Type-approval of integral shield  
systems in UN Regulation No. 129  
**Proposals for discussion**

Costandinos Visvikis  
14.03.2016

Figure 2

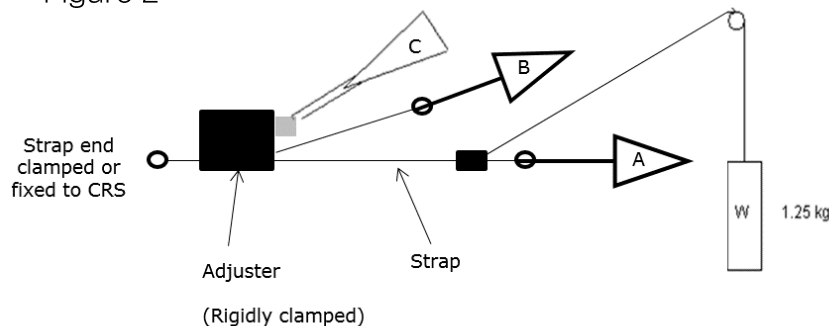
Annex 15, amend to read:

Description of conditioning of adjusters connected to a strap

1. Method
- 1.1. Rigidly clamp the adjuster
- 1.2. With the strap set at the reference position described in paragraph 7.2.6., withdraw at least 50 mm of strap from the adjuster by pulling on the free end of the strap.
- 1.3. Attach the adjusted part of the strap to the pulling device A.
- 1.4. Activate the adjuster (C) and pull at least 150 mm of strap through the adjuster. This represents half of one cycle and puts pulling device A to the maximum strap extraction position.
- 1.5. Connect free end of strap to pulling device B.

2. The cycle is:
  - 2.1. Pull B at least 150 mm whilst A exerts no tension on the strap.
  - 2.2. Activate the adjuster (C) and pull A whilst B exerts no tension on the free end of the strap.
  - 2.3. At the end of stroke, de-activate the adjuster.
  - 2.4. Repeat cycle as specified in paragraph 6.7.2.7. of this Regulation
